## Brookhaven National Laboratory Plant Engineering - E&CS Division Engineering Change Notice Form

PROJECT: CCWF II

JOB No. 11705

ECN Title: Fire Supply Piping Valve

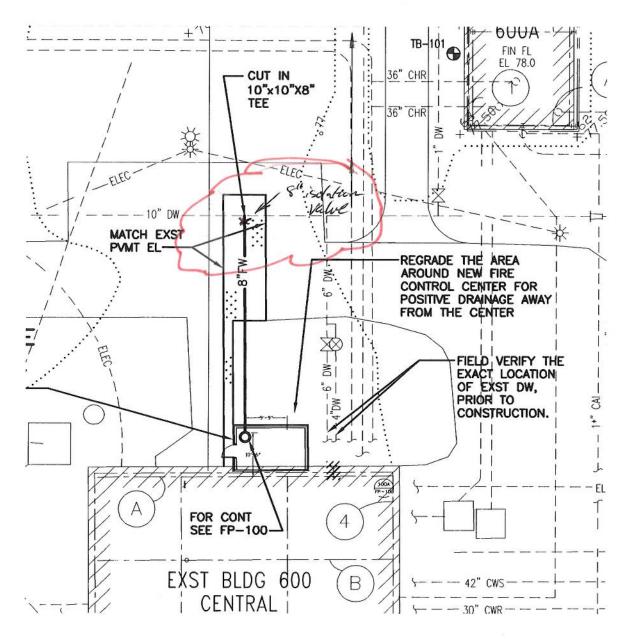
Affected Documents: Drawing CE-03			
Requested Change (Attach sketch if applicable): New tee for fire service requires an 8" valve for service isolation See attached sketch for proposed solution.			
Requested by:	A. Raphael		Date: 9/28/09
Resolution: Provide as shown on attached sketch.			
Approvals:	A/E or Proj. Eng.: Theresque (a) Project Coordinator: All Reflect Manager: 44	SYLAHISVILE	Date: 9/2/09  Date: 10/2/09  Date:
Contractor shall take the following action:			
	Await change order from P&PM Proceed with change as described Provide cost proposal for change as	described	
Distribution:	E. W. Howell	Giffels	
	E&U	MPO	
	O&M	ECN File	
	NSLS II	DE

Leolation value to be 8" Mueller with value box to grade.
